18 VINE HILL
LONDON
DESIGN AMENDMENT STATEMENT
TO SUPPORT A SECTION 73 APPLICATION

AUGUST 2020 | 8060_L(00)214C

This document has been prepared by Leach Rhodes Walker in support of a Section 73 application to outline the design amendments proposed to the previously consented scheme (Ref 2018/6016/P) for the site located at 18 Vine Hill and 15-29 Eyre Street Hill, Clerkenwell, London EC1R 5DZ. These have been prepared following detailed design development stages on behalf of Clerkenwell Lifestyle (UK) Ltd ('Client')

Fig. 17 Consented Room Section

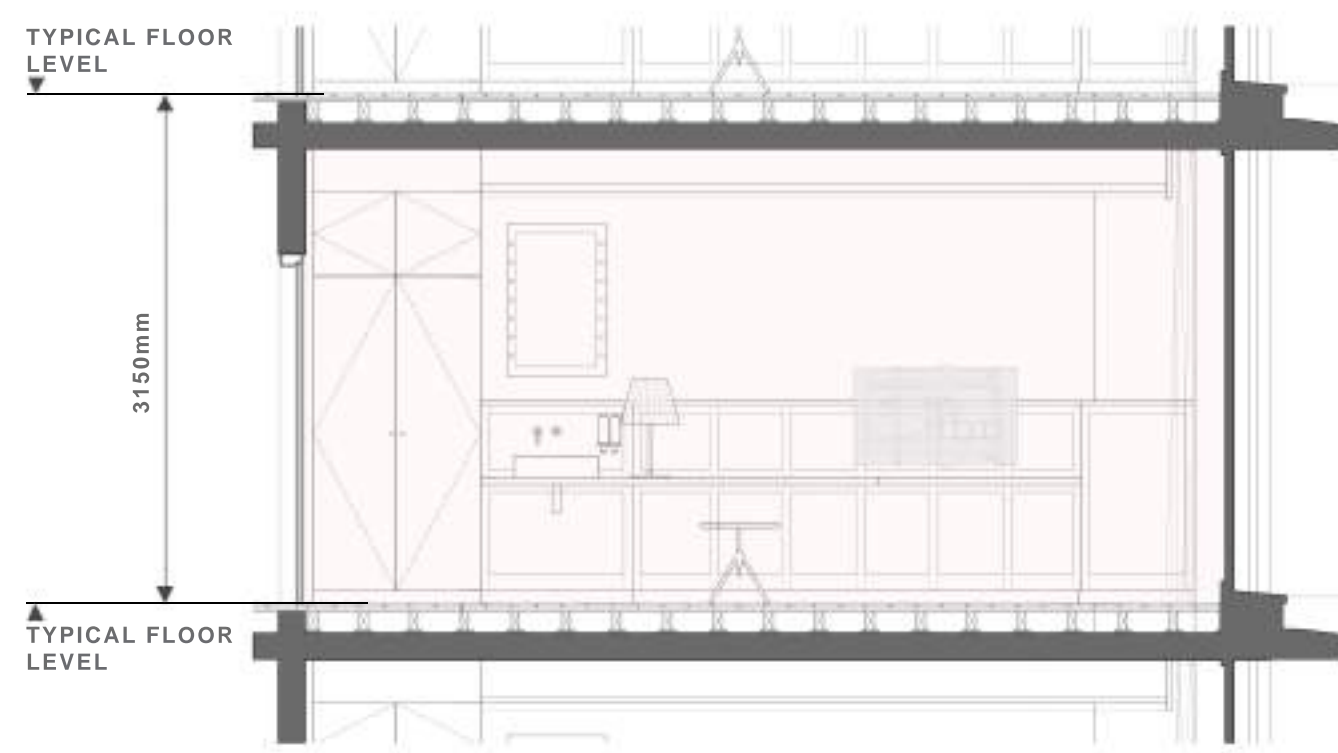
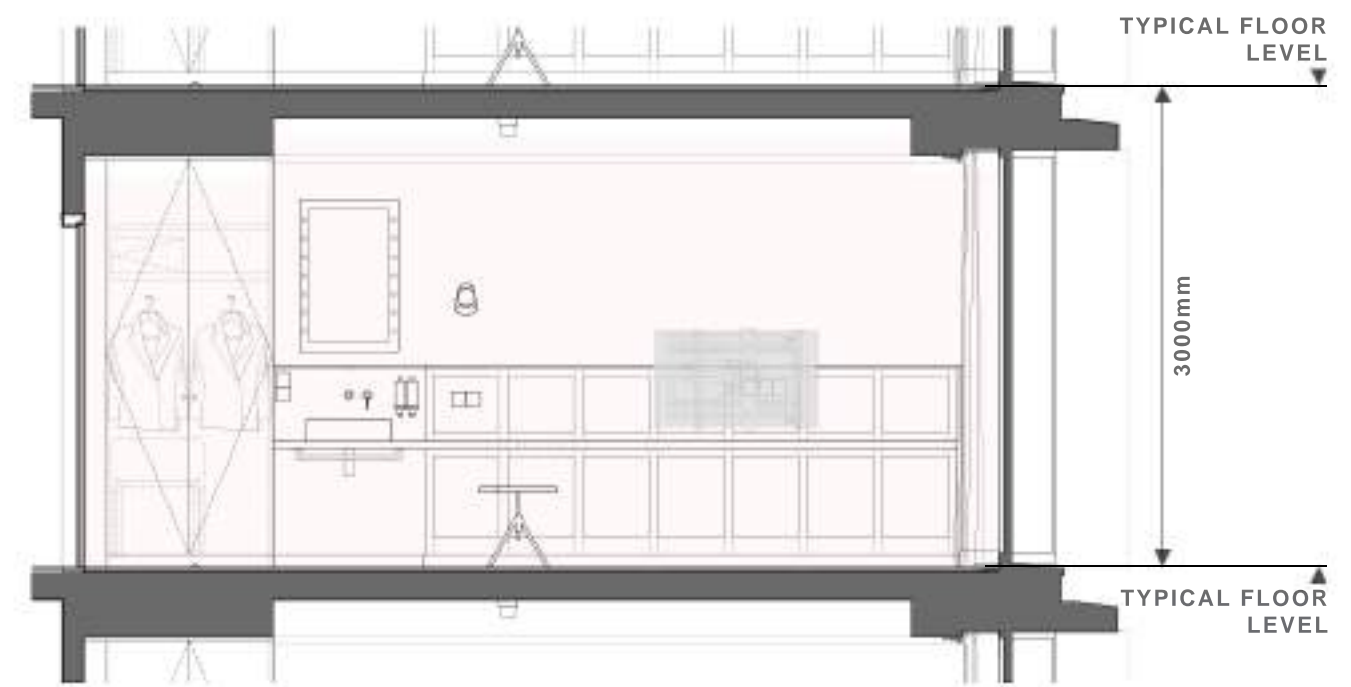
Since planning was granted, the client has been reviewing the scheme with the project team and has identified the potential to deliver the new build hotel and affordable living element of the scheme with a slightly reduced building height but still meeting the affordable housing and hoteliers' brand standards. This has been achieved by reconfiguring the hotel bedroom internal waste drainage, negating the need for the 150mm raised access floor allowed for in the consented design. The typical floor to floor heights are reduced from 3.15m to 3.00m, culminating in an overall building height reduction of 0.9m. The floor to ceiling height of the affordable dwellings is 2500mm.

Fig. 22 Proposed Section E-E

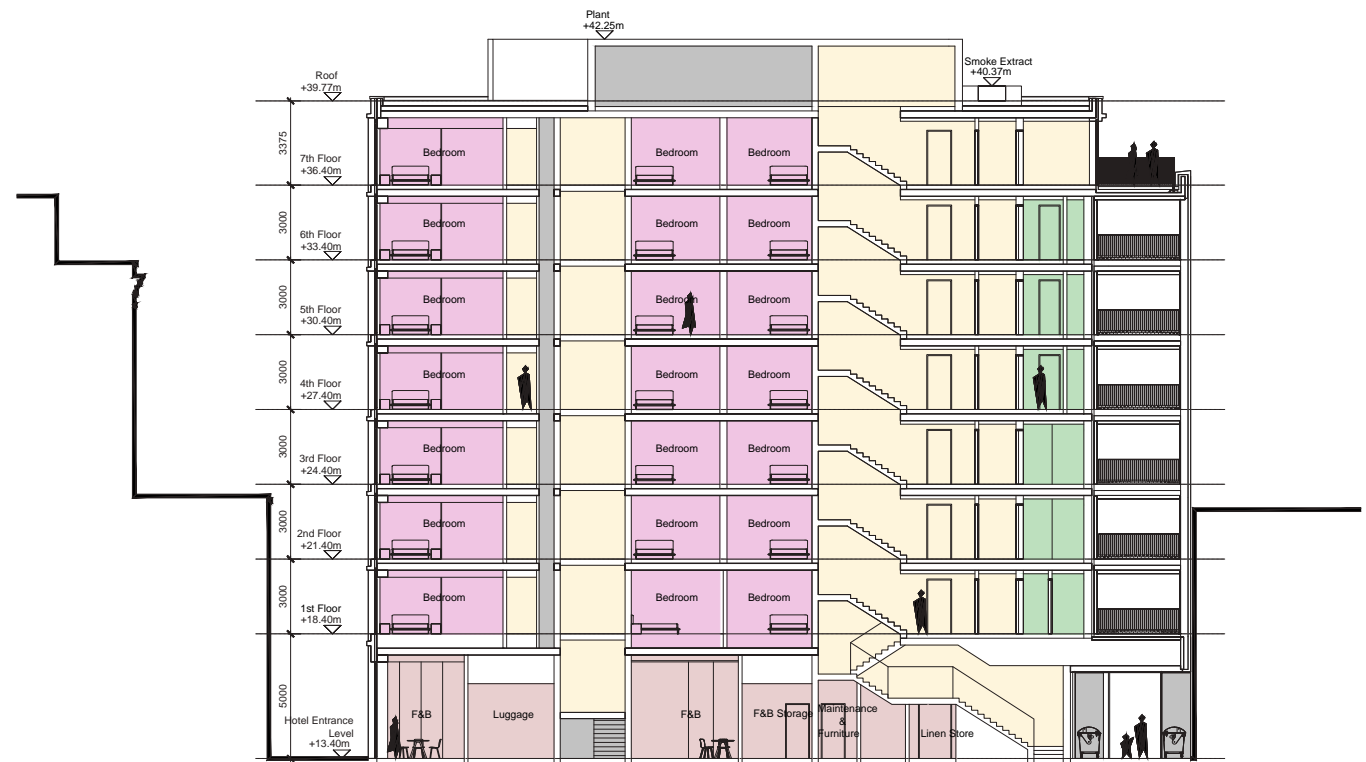
Reduction of Building Height | Section E-E Comparison

Fig. 27 Typical Room RCP

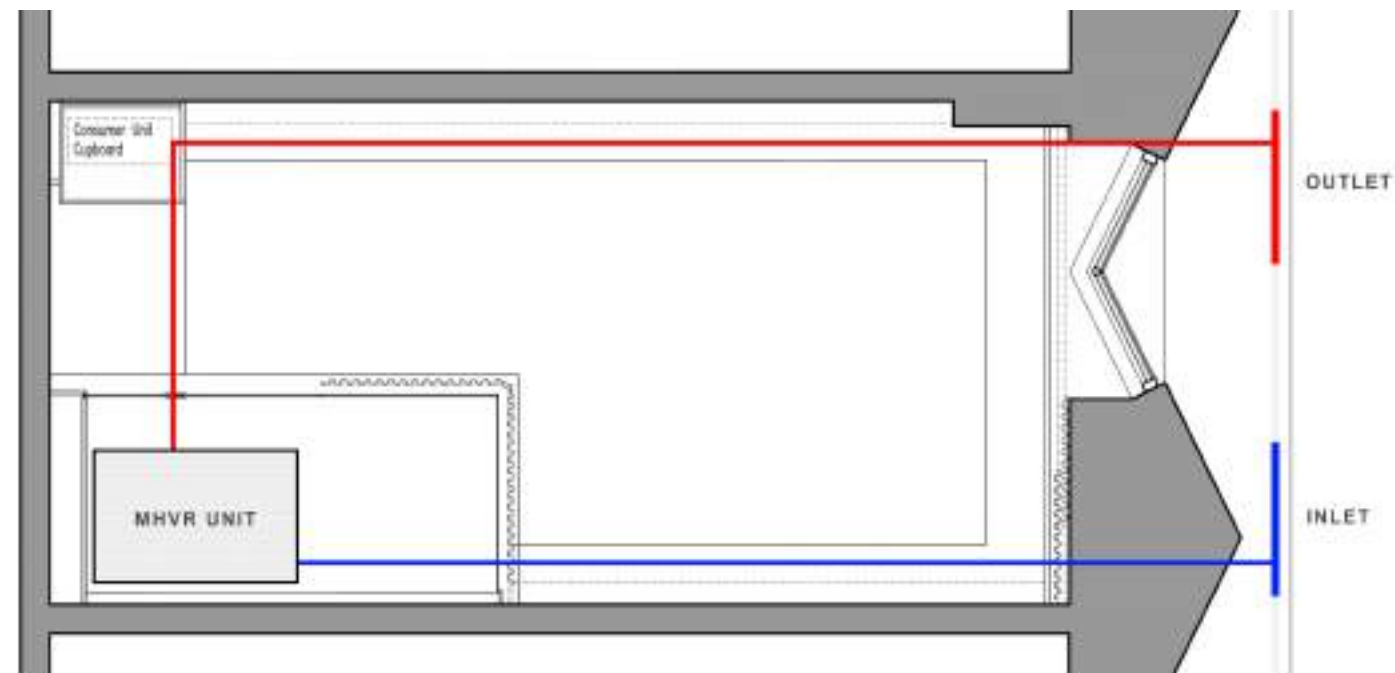
The current consent necessitates two ventilation strategies within the hotel bedrooms. The rooms not facing onto Eyre Street Hill have a self-contained ceiling mounted ventilation, cooling and heating (VCH) system that has air intake and extract vents located at the head of bedroom windows. All of the other remaining rooms, the internal rooms and those facing Eyre Street Hill are to rely on a centralised system that requires ductwork to rooftop plant area.

By changing the proposed construction of the Eyre Street Hill façade, i.e. GRC panels in lieu of pre-cast concrete panels there is an opportunity to simplify the mechanical ventilation system described above. By utilising panel joints and voids to conceal intake and extract air vents it is proposed that the hotel bedrooms facing onto Eyre Street Hill have individual VCH systems. Please see the diagrams below which illustrate this proposed strategy.

Fig. 30 Consented Roof Plan

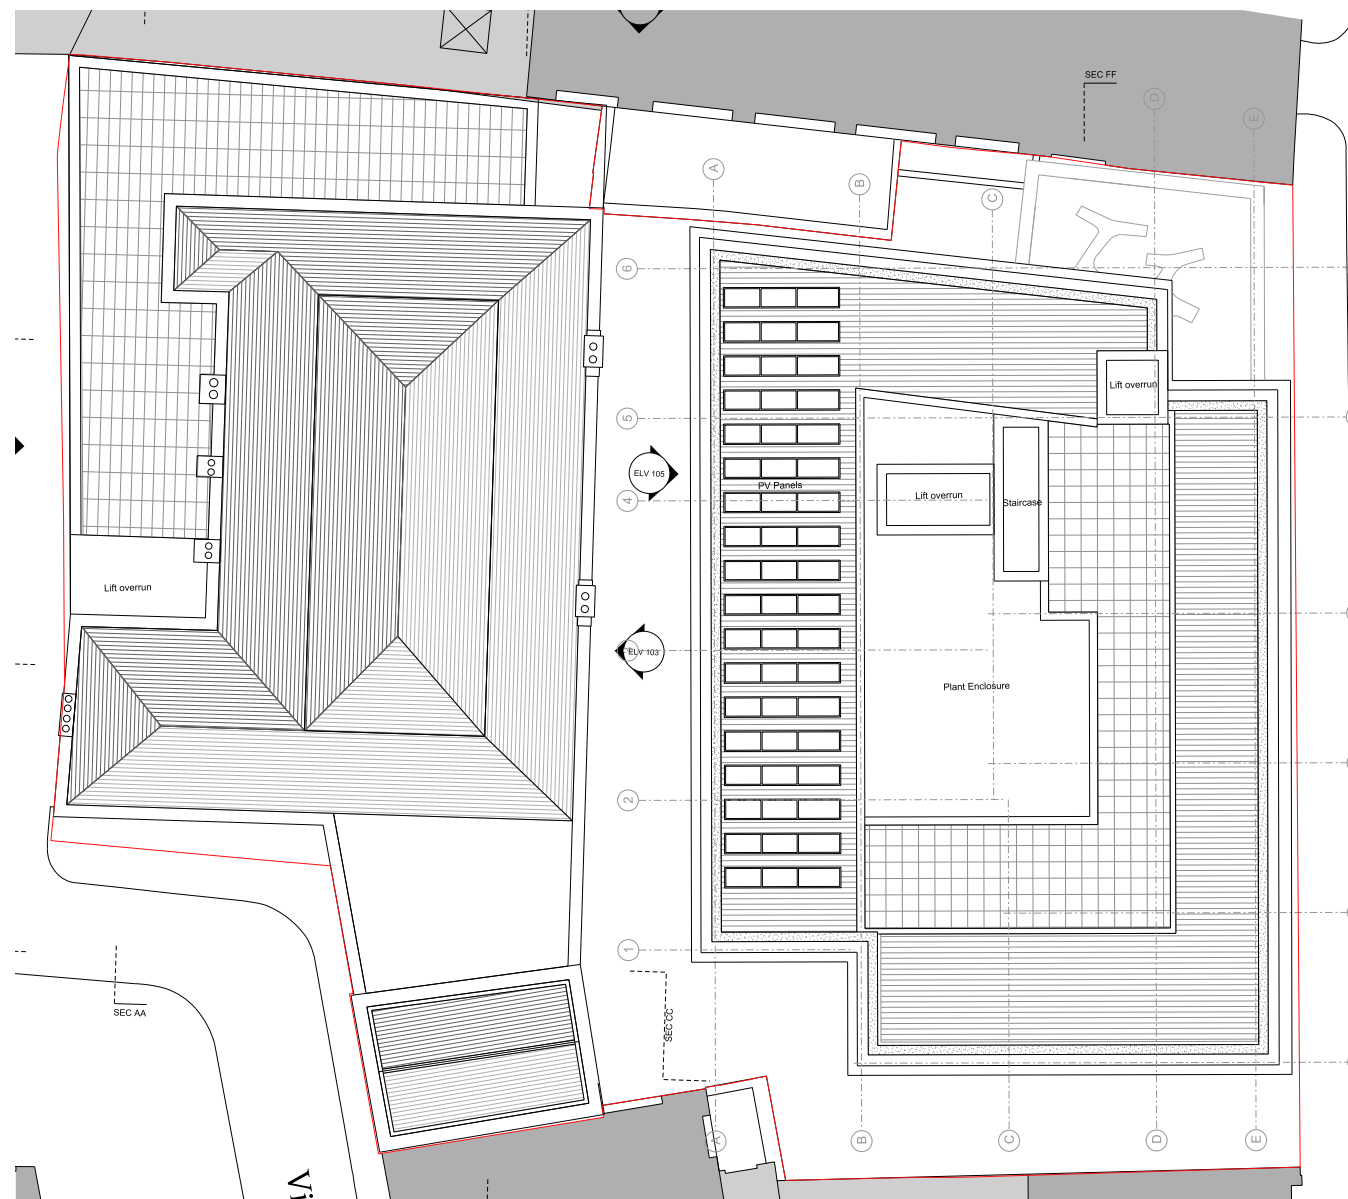
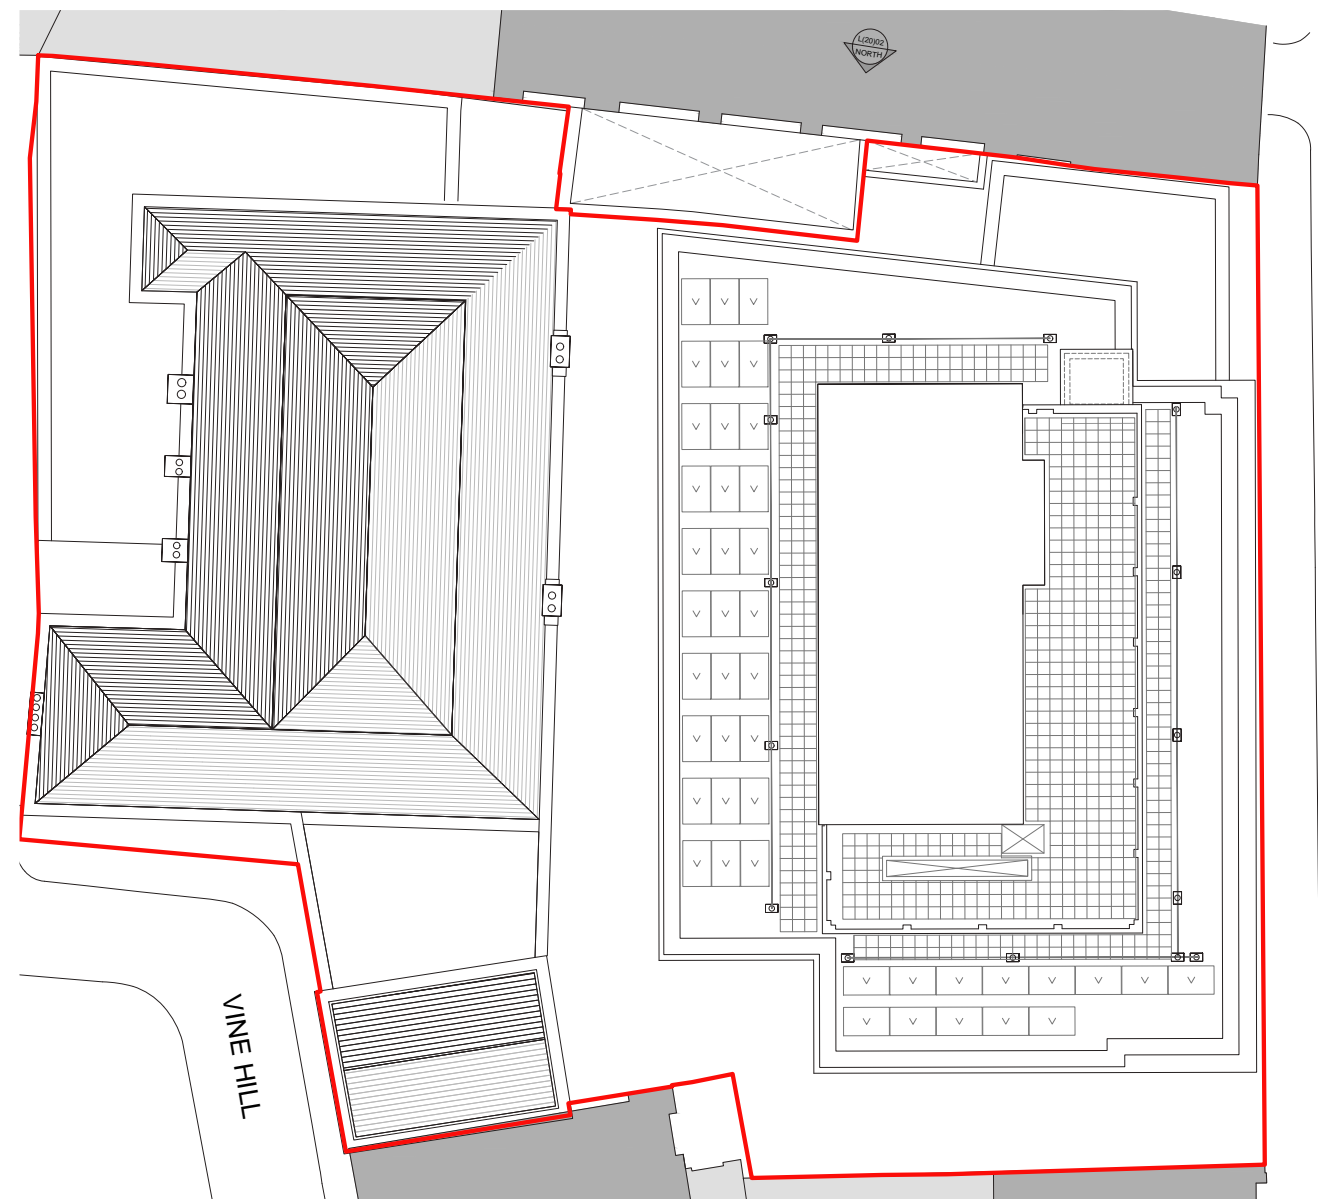
1. As part of a comprehensive detailed design process it became evident that minor changes to plantroom enclosure and external plant layouts were necessary to accommodate the access stair, maintenance access and a fall arrest system. This has resulted in the need to relocate approximately a third of the Photo Voltaic (PV) panels to the southern part of the roof; this is an improvement on the previous arrangement as this part of the roof has the best sun exposure. In addition to this the preferred supplier has proposed fewer but more efficient PV panels to meet the requirements of the approved energy strategy. It is important to note that the combined external footprint of the plantroom and louvre enclosure remains principally as per the consented drawings.

Fig. 32 Consented North Elevation

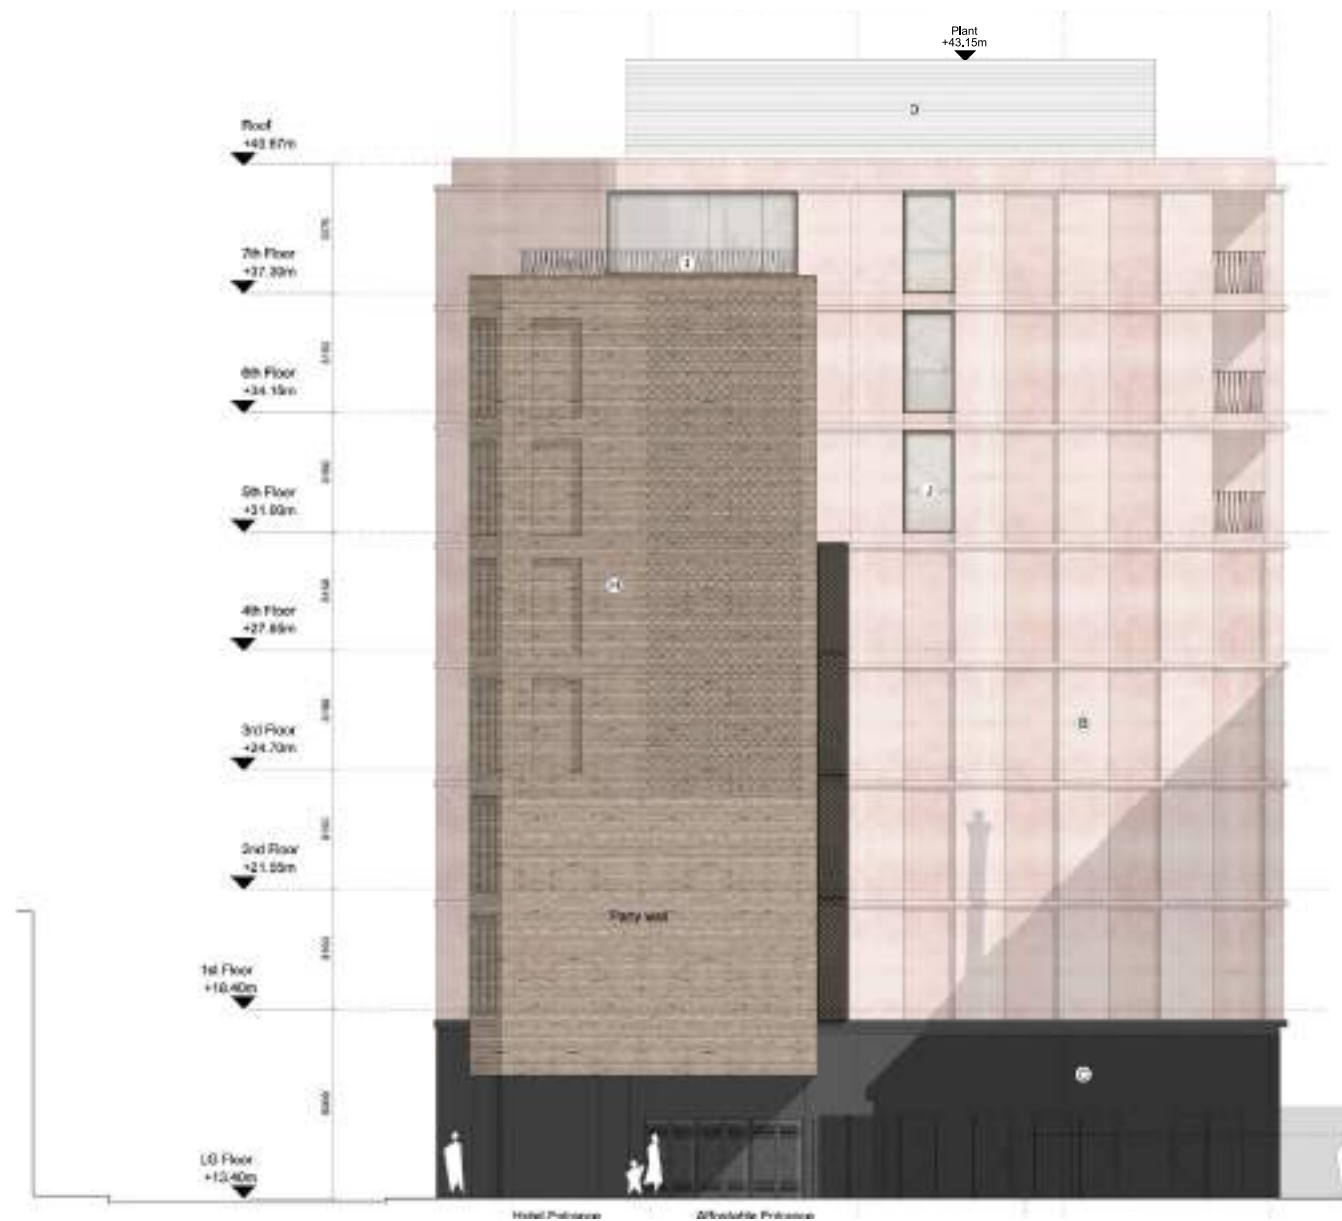
Hotel & Apartments North Elevation | Comparison
